**Environmental
Protection Agency**

December 15, 2010

RE: ROBIN MHP's INC.
PERMIT NO. 3PV00058
PORTAGE COUNTY
MANTUA

Figure 1

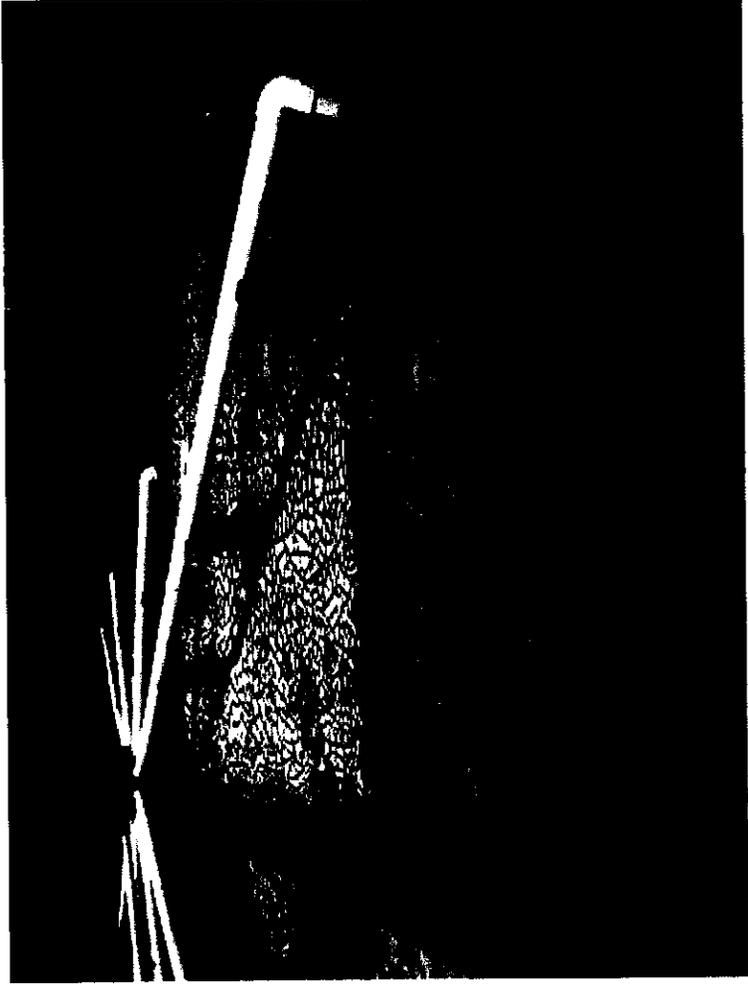
13. The weirs and the sidewalls in the settling tanks were free of solids.
14. All four surface sand filter beds were operable. The sludge layer was being raked off the beds. See Figures 1 & 2. Ms. Wieclaw indicated that the depth of the filter media was going to be evaluated and new filter media would be added as needed. Also, river rock was going to be placed around the splash pads in each filter bed. The river rock and filter media was already present at the site.
